# RECOMMENDED SERVICE BULLETIN RSB 40NG-052

Improved mounting of 2nd Alternator.

# WORK INSTRUCTION WI-RSB 40NG-052

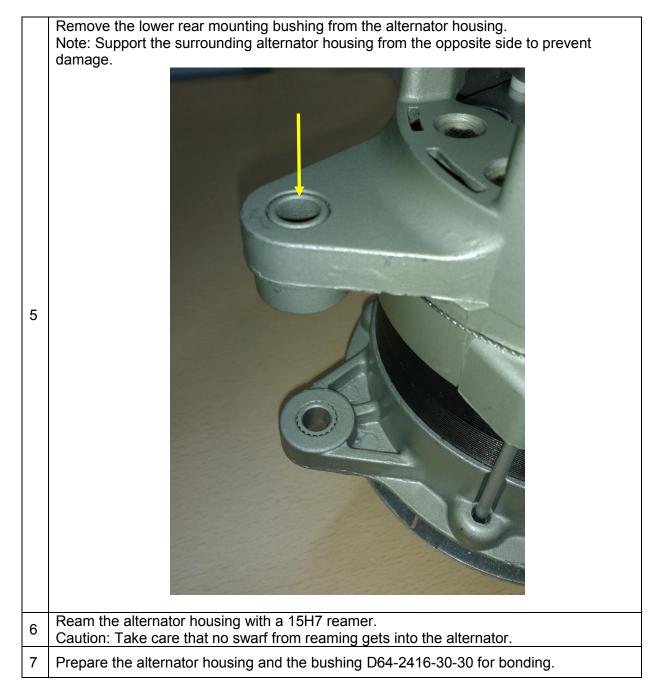
Quantity	Part No.	Description	Pos
1	LN 9338-06	Nut Hexagon, self-locking	1
1	DIN 9021-6,4-A2	Washer	2
1	D64-7106-11-30_01	Outer Alternator Bushing	3
1	D64-7106-11-31	Inner Alternator Bushing	4
1	LN 9037-M6x42	Screw, hexagon Head	5
1	MS 21042-6	Nut Double Hex, self-locking	6
1	NL3/8-SPSS	Locking Washer	7
1	NL3/8-SS	Locking Washer	8
1	AN6-12A	Bolt, Machine, Aircraft	9
1	D64-2416-30-30	Alternator Bushing	10

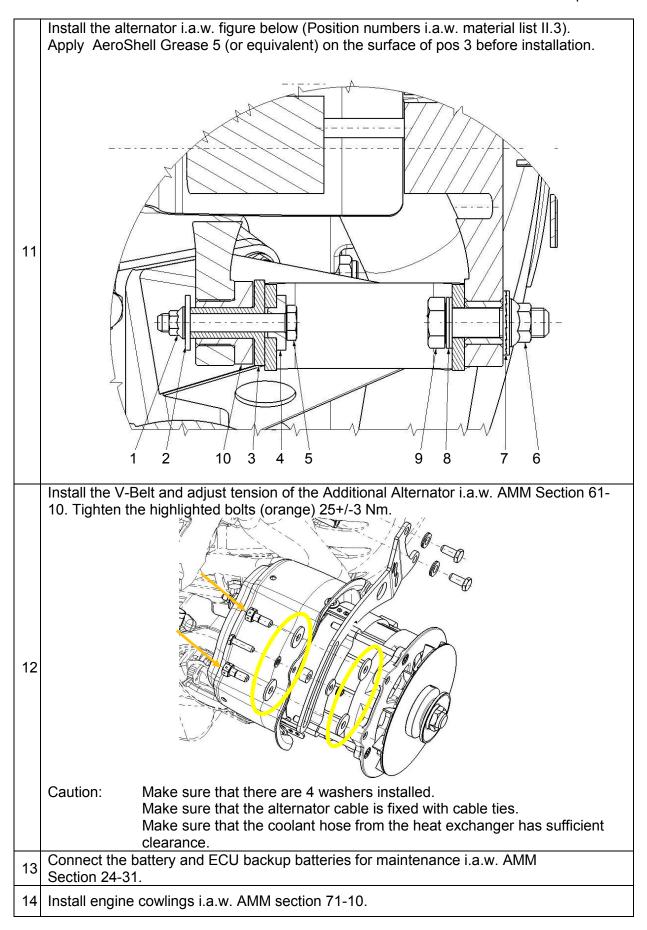
1	Remove engine cowlings i.a.w. AMM section 71-10.	
2	Disconnect the battery and ECU backup batteries for maintenance i.a.w. AMM section 24-31.	
3	Remove the additional alternator i.a.w. AMM section 61-10.	
4	Check the engine mounting arm for excessive wear on the rear attachment point, if the mounting hole diameter greater than 11 mm, replace the engine mounting arm i.a.w. AMM section 71-00.

<sup>15</sup> Minimum 24 hours after bonding of the alternator bushing do an engine run-up and test the propeller and alternator for correct operation.
